Access Compliance Report

Public Rights-of-Way

Intersection ID: 3576	Main Street: EVERCLEAR_CT	Cross Street: PRESERVATION_POINTE_DR	Location: SW
ADA ID: D2B356A8FE8B	Ramp Type: Perp	Initial Pass/Fail: Fail	Overall Compliance: No
Codes/Mitigation Info/Possible Solution			Severity Score: 25
Field Measurements/Component Compliance

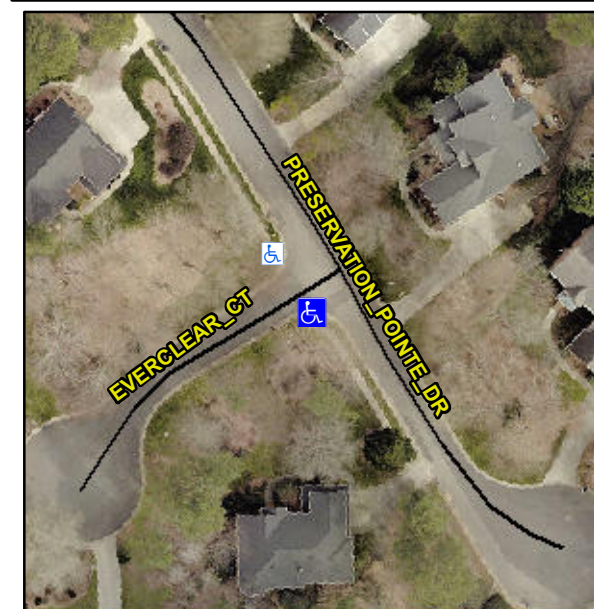
R304.2.2, R304.5.3

Compliance	Description	Data	Compliance	Description	Data
N/A	Ramp Length (in)	49.0	No	Ramp Slope (%)	9.2
Yes	Ramp Width (in)	48.0	No	Ramp XSlope (%)	6.7
N/A	Flare Type LT	N/A	N/A	Flare Type RT	N/A
N/A	Flare Slope LT (%)	N/A	N/A	Flare Slope RT (%)	N/A
N/A	Flare Traversable LT?	N/A	N/A	Flare Traversable RT?	N/A
N/A	Landing Length (in)	N/A	N/A	DWS Provided?	N/A
N/A	Landing Width (in)	N/A	N/A	DWS Contrast?	N/A
N/A	Landing Slope (%)	N/A	N/A	DWS Length (in)	N/A
N/A	Landing X Slope (%)	N/A	N/A	DWS Full Width?	N/A
N/A	Landing Curb? (Y/N)	N/A	N/A	DWS Offset (in)	N/A
N/A	Shared Landing?	N/A			
N/A	Gutter Ponding?	N/A	N/A	Gutter Slope (%)	N/A
N/A	Gutter Lip Ht (in)	N/A	N/A	Gutter X Slope (%)	N/A
N/A	Painted X Walk1?	No	N/A	Painted X Walk2?	N/A
	X Walk 1 Direction	To NW		X Walk 2 Direction	N/A
N/A	X Walk 1 Width (in)	N/A	N/A	X Walk 2 Width (in)	N/A
	X Walk 1 Slope (%)	3.8		X Walk 2 Slope (%)	N/A
	X Walk 1 X Slope (%)	9.6		X Walk 2 X Slope (%)	N/A

Remove & Replace Entire Ramp.
